Appendix A: Addendum to Design and Access Statement to explain revised scheme - pg 1

Planning Ref: HGY/2022/2212

Revised Scheme
43 Belmont Avenue N17 6AX
Proposed Block plan (showing lower ground floor)
Scale: 1:200@A3 May 2022 **PP_09 revA**

PP_16 revA

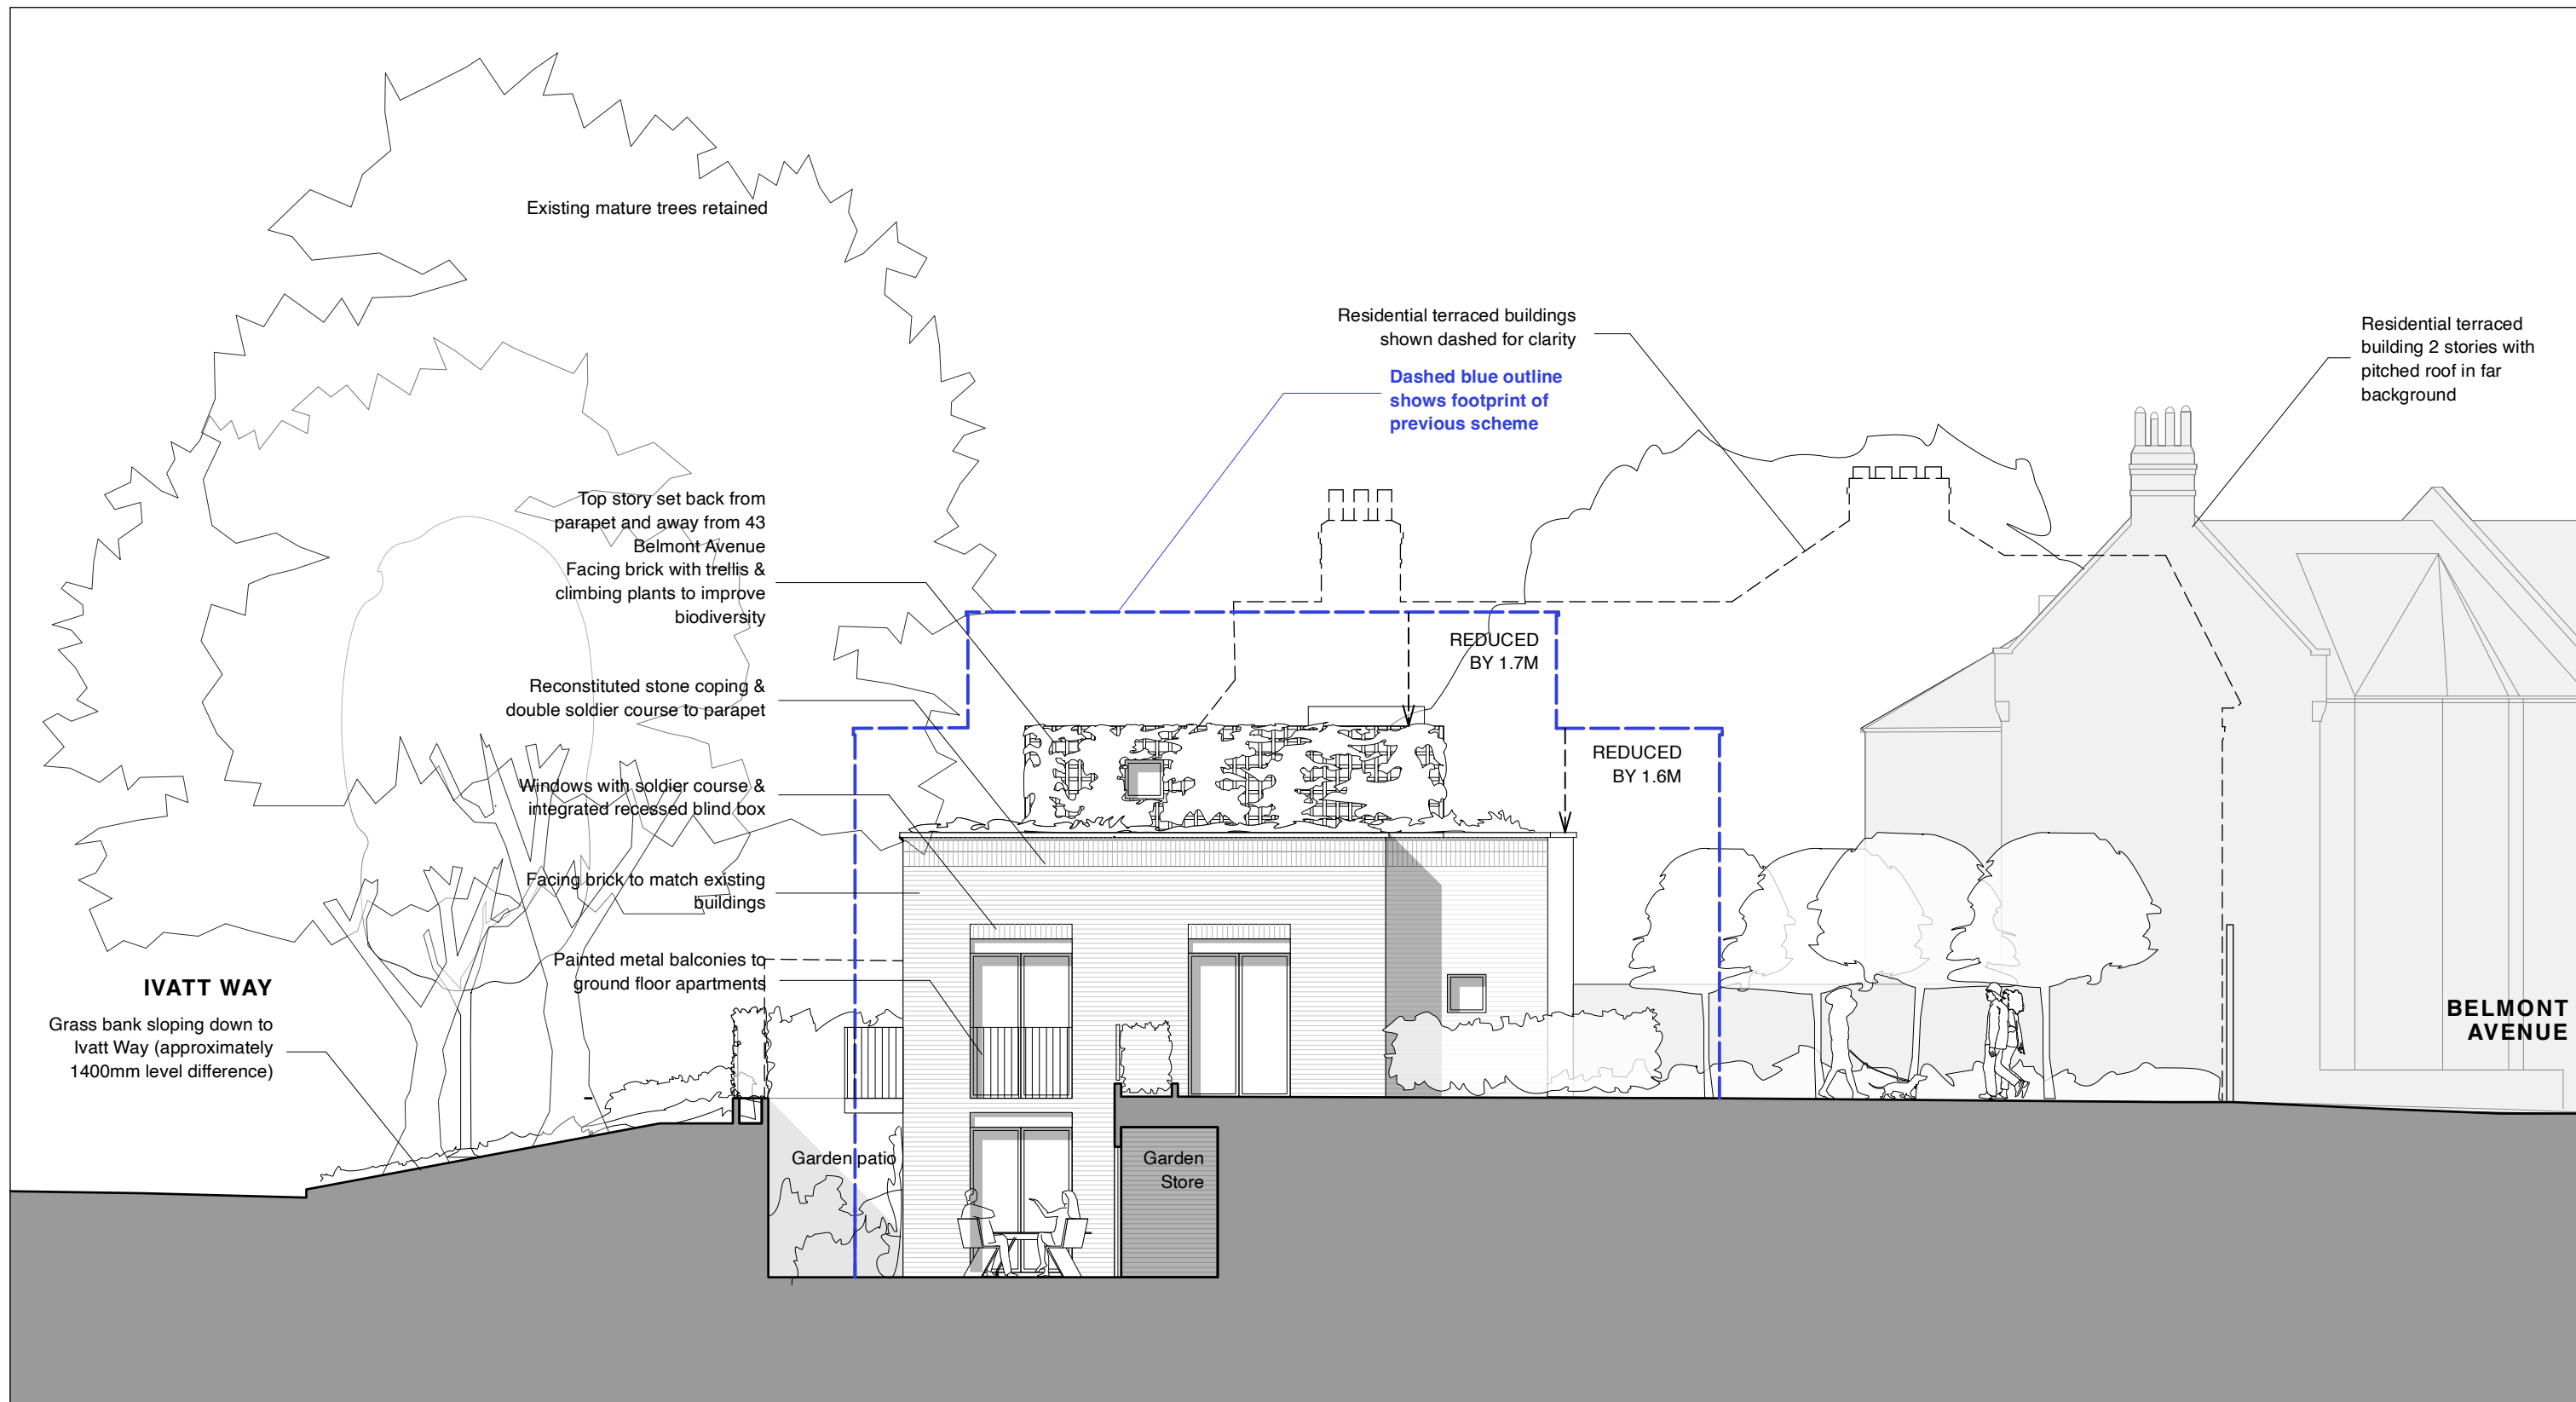
- Scheme re-designed to significantly reduce overall footprint, height and massing of the proposed development.
- The gross internal area is reduced by 80 m2 or 20% overall from the original design; the equivalent to a three bedroom apartment.
- Proposed accommodation reduced from five, two bedroom flats down to a mix of three one bedroom flats and two, two bedroom flats.
- The revised design is set back from all site boundaries as shown to avoid impact on neighbouring properties and their gardens.
- Windows have been relocated to avoid any potential overlooking to neighbouring properties and their gardens.
- The size and quality of outdoor amenity space has been increased to all proposed units.
- Landscape proposal has been revised to increase planting and relocate recycling and refuse stores as well as secure bicycle storage.
